SAFETY RECALL BULLETIN

CAMPAICH				SR-20-004
				September 2020
				MODEL: SEE BELOW
CIRCULATE TO:	[X] GENERAL MANAGER	[X] PARTS MANAGER		[X] TECHNICIAN
[X] SERVICE ADVISOR	[X] SERVICE MANAGER	[X] WARRANTY PROCESSOR		[X] SALES MANAGER

This Safety Recall Bulletin provides instructions and procedures for the modification of the second row center seat belt, related labels, inserts, and replacement of the second row right hand side seat belt (if needed).

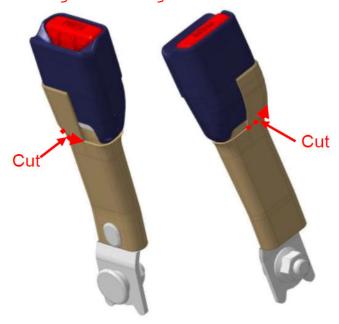
Step 6: Cut **from** Marking 2 to Marking 1 along Marking 3 in **clockwise** direction.

Step 7: Cut **from** Marking 2 to Marking 1 along Marking 3 in **counterclockwise** direction. **Caution:** Do not damage webbing when cutting.

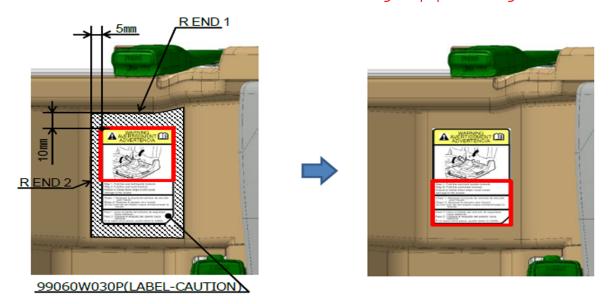
Step 12: Put the warning label (Part # MW400278) in the center of the hatching area (left top edge: 10 mm down from R END 1, 5 mm right from R END 2), remove upper side of paper backing and adhere label by rubbing your finger from center to left and then right until air bubbles are removed.

Step 13: Remove lower side of paper backing and adhere label by rubbing your finger from center to left and right until all air bubbles are removed.
